# Access Compliance Report

## Public Rights-of-Way

### (Curb Ramps)

Intersection ID: 49702	Main Street: SCOTTSMAN TRACE DR	Cross Street: MILL RIVER LN	Location: SE
ADA ID: FF131EC40F28	Ramp Type: BlendTrans2	Initial Pass/Fail: Fail	Overall Compliance: No
Severity Score: 25			
Codes/Mitigation Info/Possible Solution		Field Measurements/Component Compliance

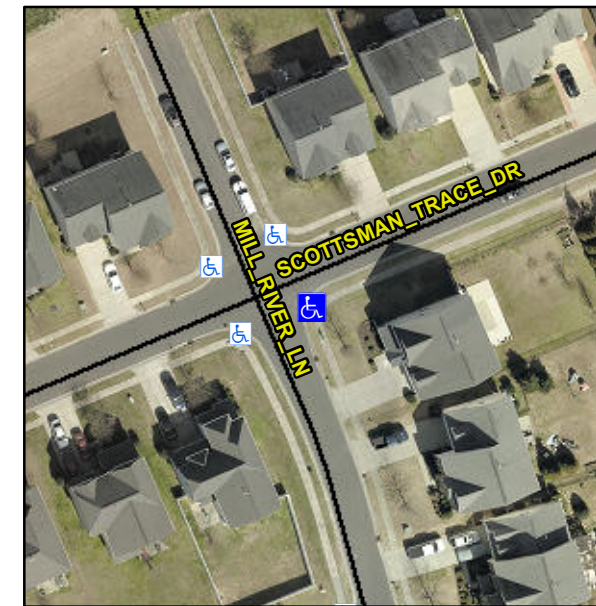
**Not Found, R304.5.3**

Compliance	Description	Data	Compliance	Description	Data
N/A	Ramp Length (in)	95.0	Yes	BlendTrans Slope (%)	3.1
Yes	Ramp Width (in)	48.0	No	BlendTrans XSlope (%)	7.2
N/A	Flare Type LT	N/A	N/A	Flare Type RT	N/A
N/A	Flare Slope LT (%)	N/A	N/A	Flare Slope RT (%)	N/A
N/A	Flare Traversable LT?	N/A	N/A	Flare Traversable RT?	N/A
N/A	Landing Length (in)	N/A	N/A	DWS Provided?	N/A
N/A	Landing Width (in)	N/A	N/A	DWS Contrast?	N/A
N/A	Landing Slope (%)	N/A	N/A	DWS Length (in)	N/A
N/A	Landing X Slope (%)	N/A	N/A	DWS Full Width?	N/A
N/A	Landing Curb? (Y/N)	N/A	N/A	DWS Offset (in)	N/A
N/A	Shared Landing?	N/A			
N/A	Gutter Ponding?	N/A	N/A	Gutter Slope (%)	N/A
N/A	Gutter Lip Ht (in)	N/A	N/A	Gutter X Slope (%)	N/A
N/A	Painted X Walk1?	No	N/A	Painted X Walk2?	No
	X Walk 1 Direction	To NW		X Walk 2 Direction	To SW
	X Walk 1 Width (in)	N/A		X Walk 2 Width (in)	N/A
	X Walk 1 Slope (%)	4.9		X Walk 2 Slope (%)	1.0
	X Walk 1 X Slope (%)	1.9		X Walk 2 X Slope (%)	0.3

N/A	Ramp inside XWalk1?	N/A	N/A	Ramp inside XWalk2?	N/A
	Road Slope (%)	1.3		Clear Space?	N/A
	Road X Slope (%)	0.5	N/A	Clear Space to XWalk (in)	N/A
N/A	Any Obstructions?	N/A	N/A	Storm Grate/Utility Hazard?	N/A
	Obstruction Type			Storm Grate/Utility Type	
		N/A			N/A
			Yes	Surface Condition? (G/P)	Good
			No	Curb Slope (%)	8.0

**Remove & Replace Curb Ramp With Two New Directional Ramps or Equivalent.**
